DEVELOPMENT REVIEW BOARD  
SUPPLEMENTAL SUBMITTAL

PROJECT NO. 2018-001579

This letter outlines the modifications that have been made to the Apartments at Pennsylvania and Indian School application for a major site plan amendment to the approved Winrock Town Center Site Development Plan (PR-2018-001579) to address the agency comments that were received.

APARTMENTS AT INDIAN SCHOOL & PENNSYLVANIA  
 7500 INDIAN SCHOOL RD NE  
 ALBUQUERQUE, NM, 87110

**CONCEPTUAL UTILITY PLAN**

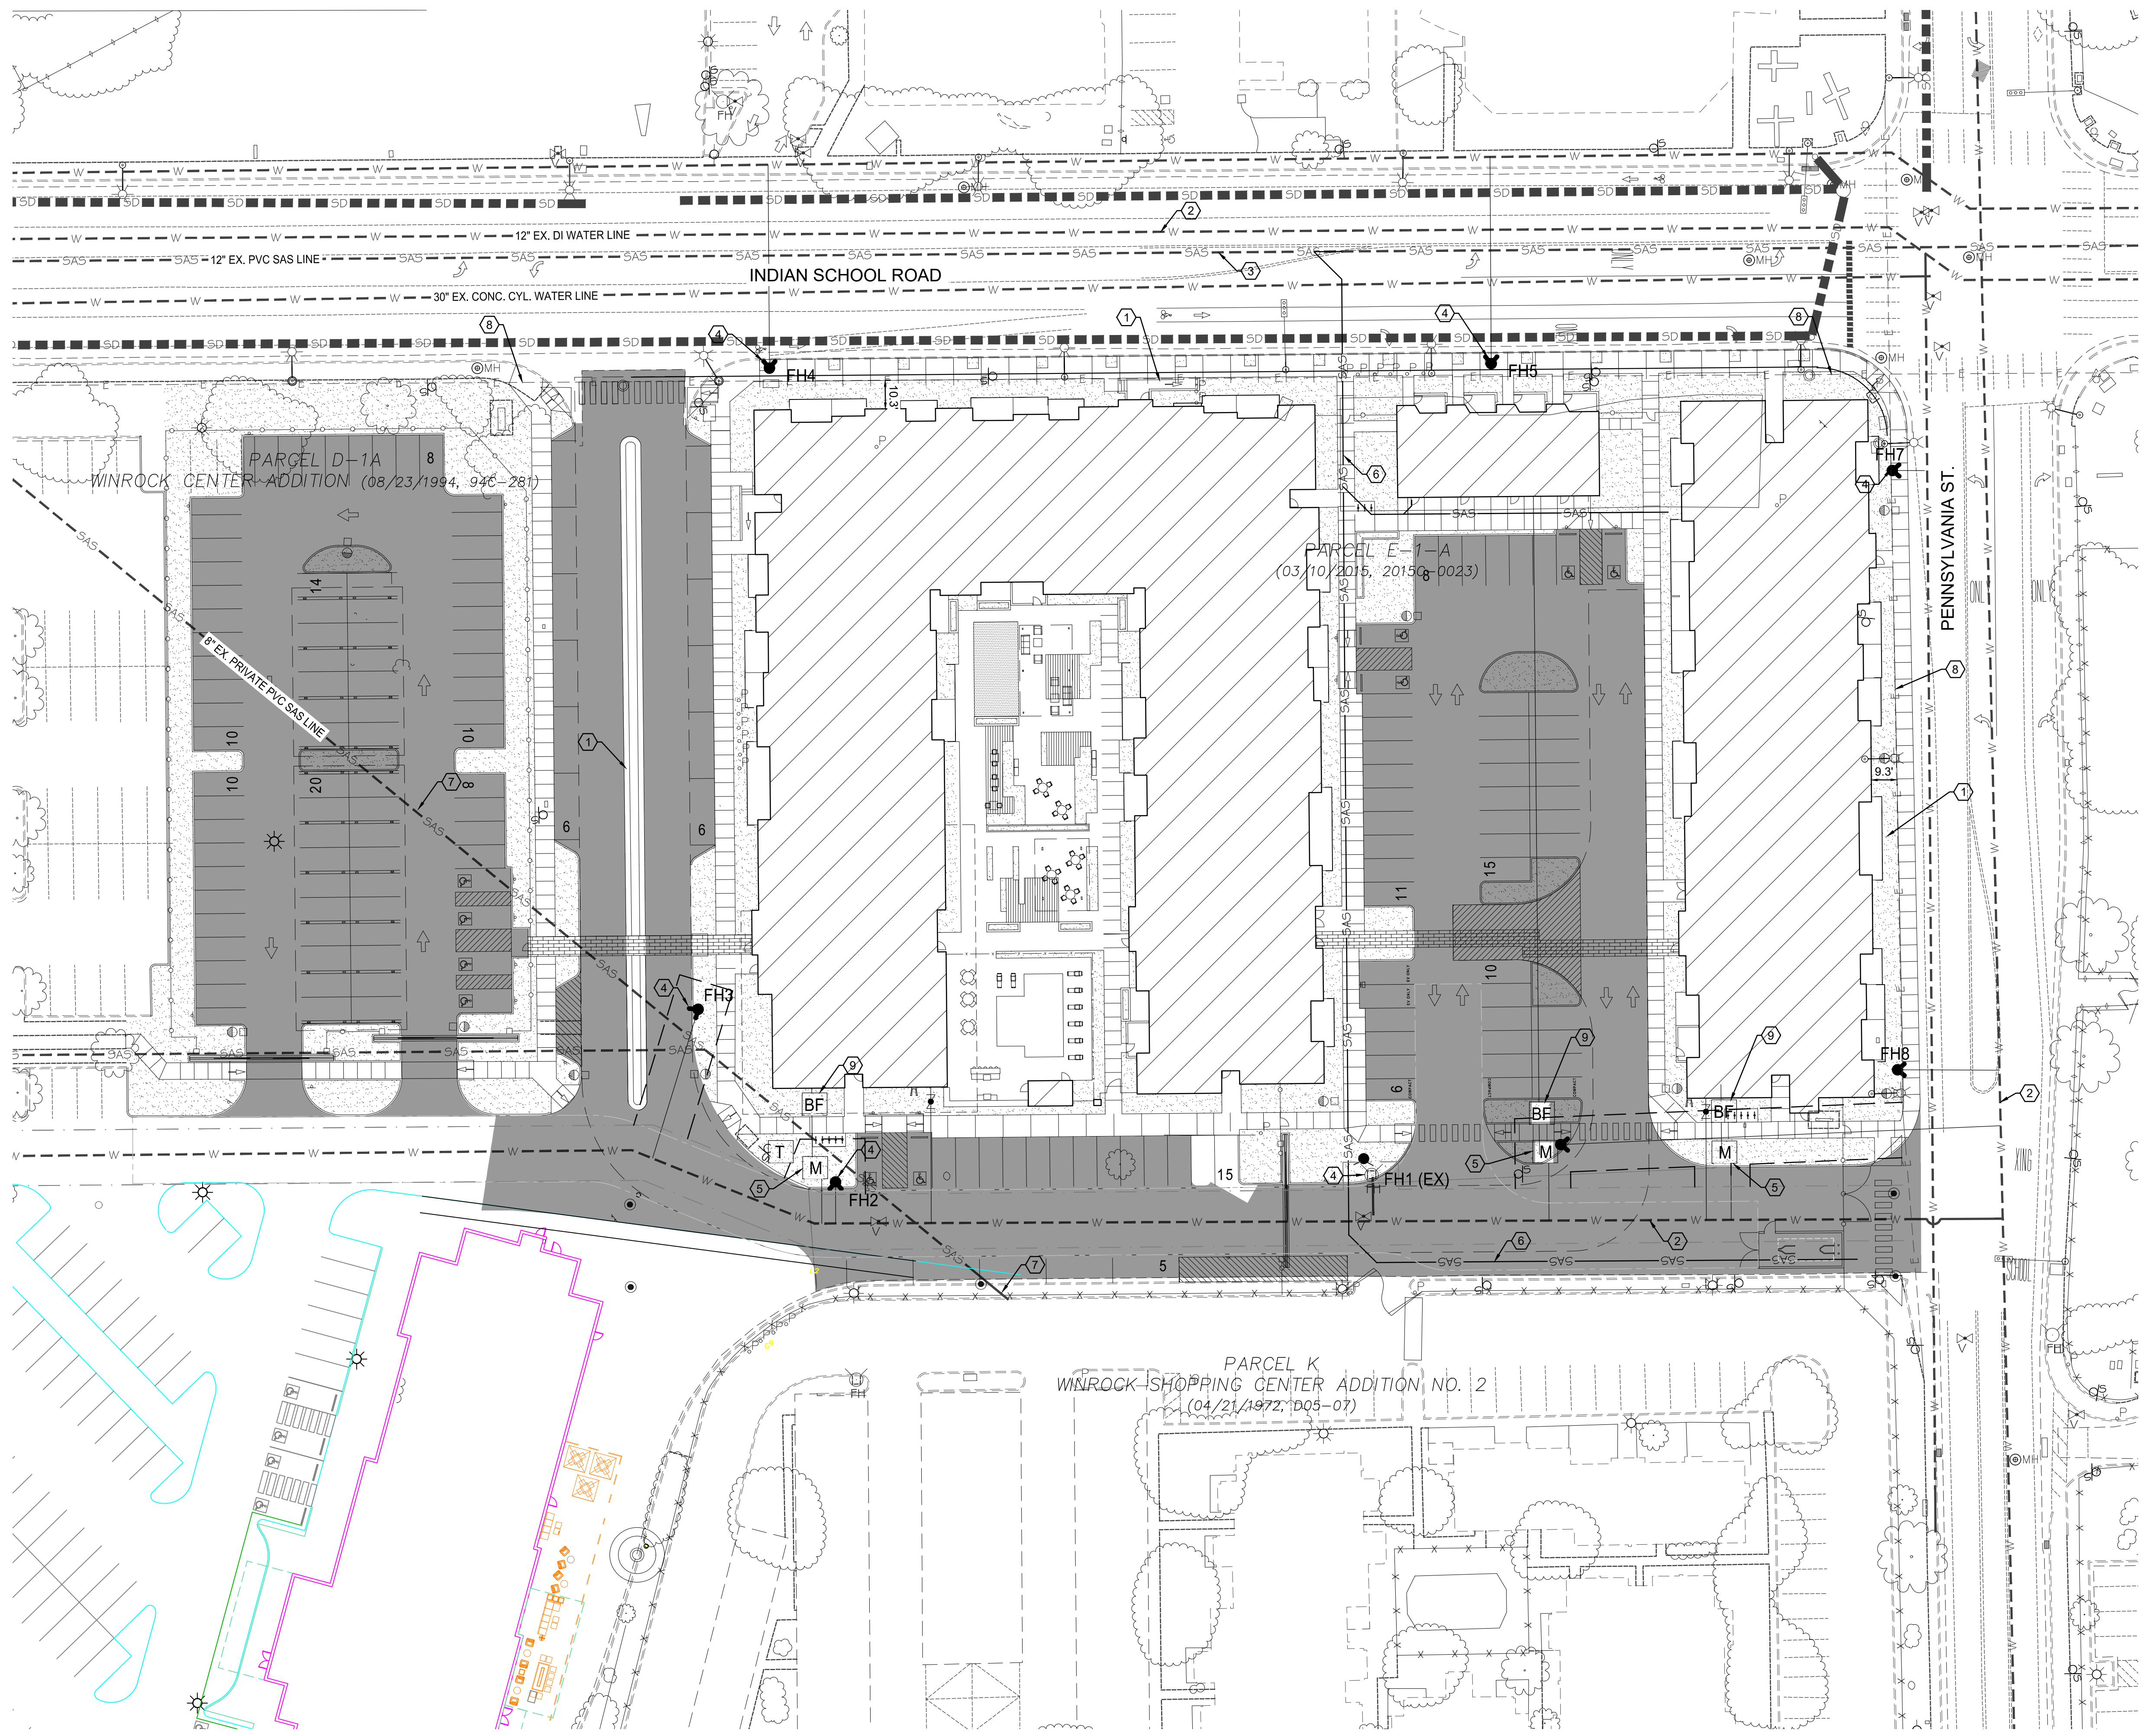
- i. **Please confirm fire flow. Is it really 6,000 gpm? Is there no fire suppression system?**

- ii. **Please show backflow prevention at domestic services. The Cross Connection Ordinance considers multi-family residential with three stories or greater to be non-residential and requires a backflow preventer.**

- iii. **The proposed fire hydrant connections along Indian School Rd. and Pennsylvania St. appear to connect to waterlines that are not appropriate for connection. Please refer to availability statement #201105.**

- iv. **The availability statement requires that the proposed fire hydrant between existing FH1 and proposed FH8 be relocated to connect to the existing waterline along Pennsylvania St.**

- v. **Is an easement needed for the proposed private fire hydrant #3 given that the waterline may be located offsite?**

- vi. **There are features shown as "M". Please include a legend to clarify. The proposed features "WM" are also not explained. Which symbols are water meters?**

- vii. **What is the horizontal clearance between the proposed private sanitary sewer along the south property line and the existing public waterline? Is**

**the appropriate clearance provided? Is the proposed sanitary sewer encroaching into the public waterline easement?**

*The reduction of fire flow was not realized on the Fire One plan. The reduction results in a fire flow demand of 3,000 gpm.*

*The updated Conceptual Utility Plan includes backflow prevention on the domestic services which are located on the user side of the water meter.*

*The updated Conceptual Utility Plan connect provide connections into more appropriate waterlines within Indian School Rd and Pennsylvania St.*

*The updated Conceptual Utility Plan indicates fire hydrant #6 connect to waterline along Pennsylvania St.*

*Yes and a 20-foot wide waterline easement has been added to the Conceptual Utility Plan and Preliminary Plat.*

*A legend has been added to the Conceptual Utility Plan and annotation corrected.*

*The horizontal clearance between the proposed private sanitary sewer line existing public waterline is greater than 10-feet. The existing public waterline easement is shown on the revised Conceptual Utility Plan.*

**PROPOSED DRIVE AISLE ASPHALT PAVEMENT SECTION**

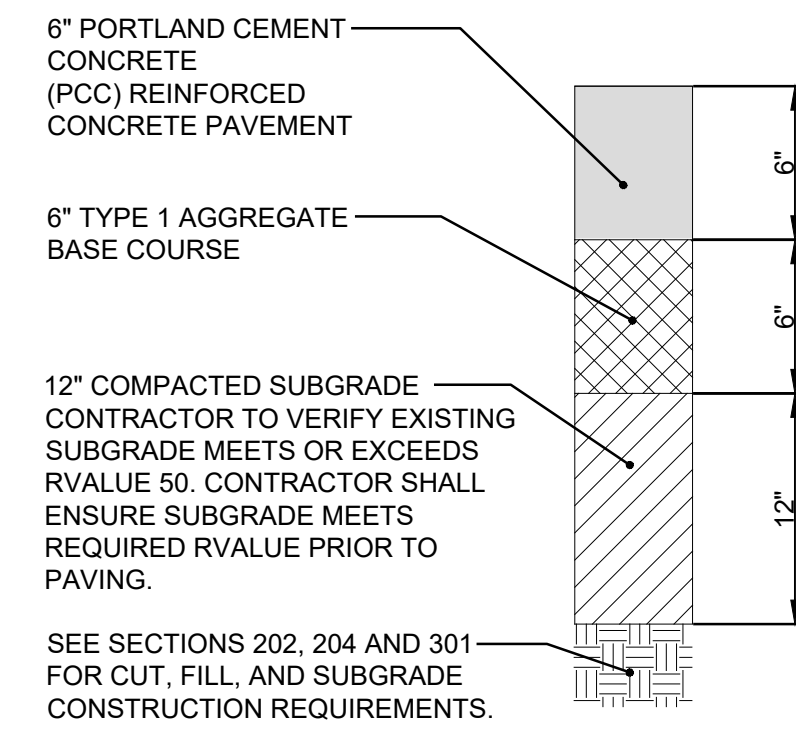
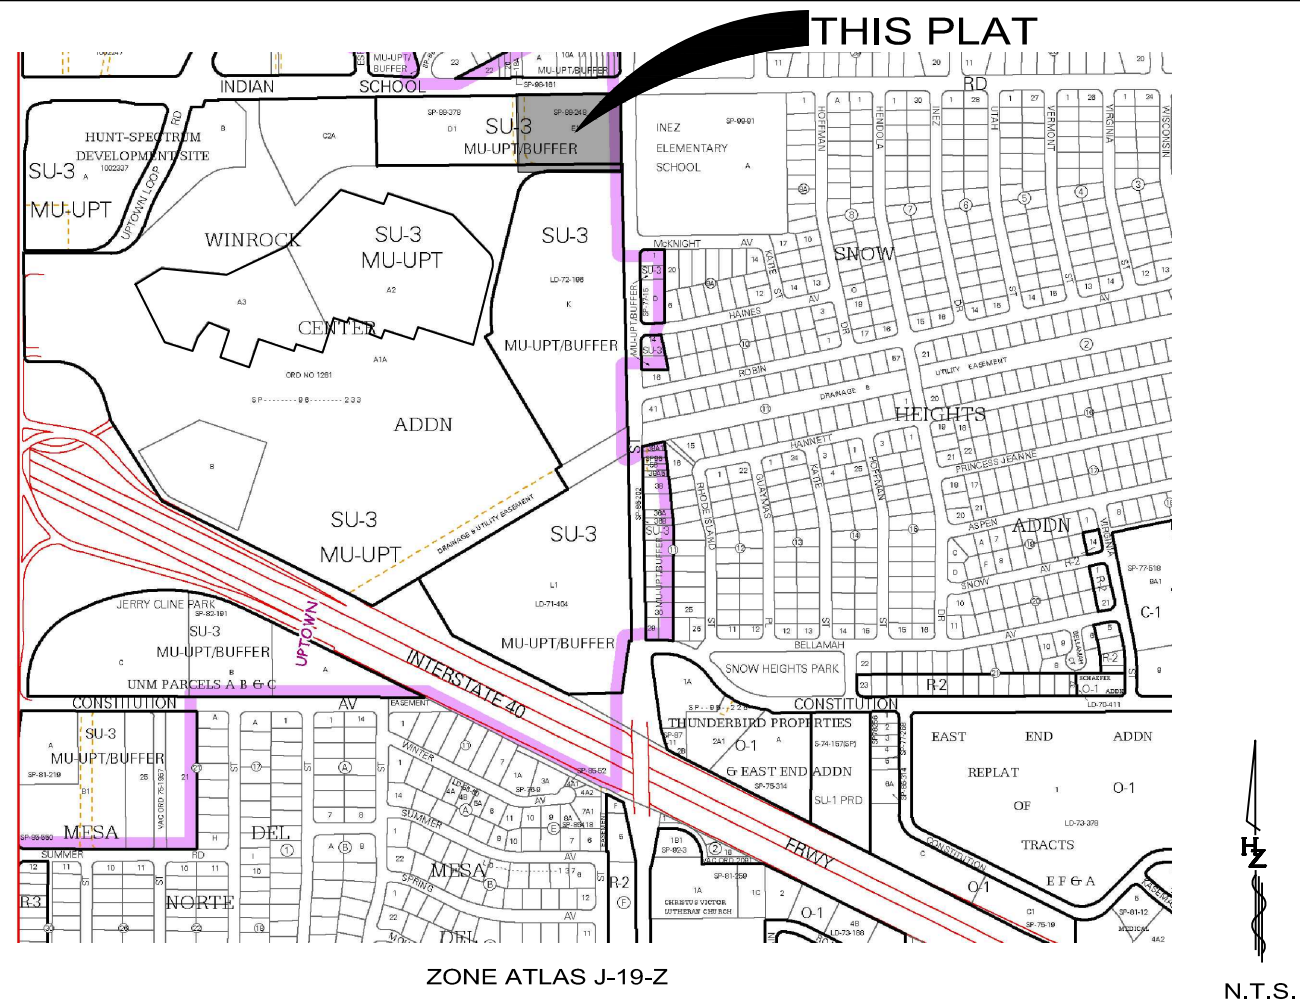
- 12. Provide both an asphalt pavement section and a detailed section for the patterned crosswalk.**

*These details are included on sheet C400.*
